Access Compliance Report

Public Rights-of-Way

(Curb Ramps)

Intersection ID: 44016	Main Street: ATWATER_LN	Cross Street: MANTARIO_DR	Location: S
ADA ID: E8AB96C41D20	Ramp Type: PerpDiag	Initial Pass/Fail: Fail	Overall Compliance: No
		Severity Score: 42.5

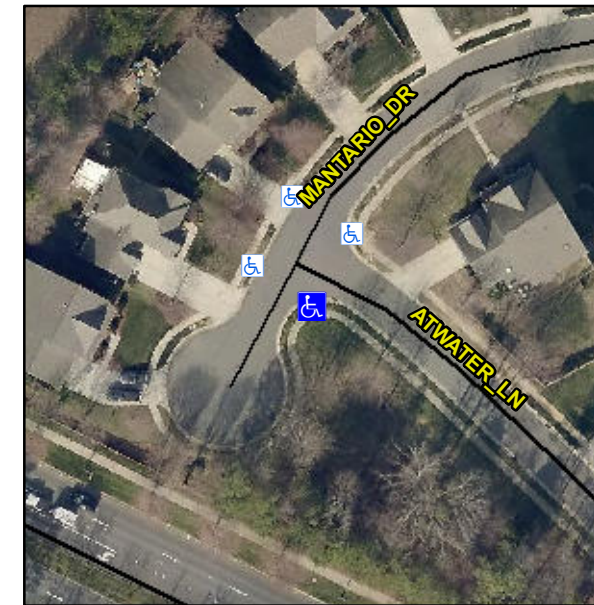
R304.5.1, R304.2.2, R304.5.3

Compliance	Description	Data	Compliance	Description	Data
N/A	Ramp Length (in)	48.0	No	Ramp Slope (%)	8.4
No	Ramp Width (in)	35.0	No	Ramp XSlope (%)	5.8
N/A	Flare Type LT	N/A	N/A	Flare Type RT	N/A
N/A	Flare Slope LT (%)	N/A	N/A	Flare Slope RT (%)	N/A
N/A	Flare Traversable LT?	N/A	N/A	Flare Traversable RT?	N/A
N/A	Landing Length (in)	N/A	N/A	DWS Provided?	N/A
N/A	Landing Width (in)	N/A	N/A	DWS Contrast?	N/A
N/A	Landing Slope (%)	N/A	N/A	DWS Length (in)	N/A
N/A	Landing X Slope (%)	N/A	N/A	DWS Full Width?	N/A
N/A	Landing Curb? (Y/N)	N/A	N/A	DWS Offset (in)	N/A
N/A	Shared Landing?	N/A			
N/A	Gutter Ponding?	N/A	N/A	Gutter Slope (%)	N/A
N/A	Gutter Lip Ht (in)	N/A	N/A	Gutter X Slope (%)	N/A
N/A	Painted X Walk1?	No	N/A	Painted X Walk2?	No
	X Walk 1 Direction	To NE		X Walk 2 Direction	To NW
N/A	X Walk 1 Width (in)	N/A	N/A	X Walk 2 Width (in)	N/A
	X Walk 1 Slope (%)	2.4		X Walk 2 Slope (%)	5.8
	X Walk 1 X Slope (%)	4.9		X Walk 2 X Slope (%)	0.8

Remove & Replace Curb Ramp With Two New Directional Ramps or Equivalent.
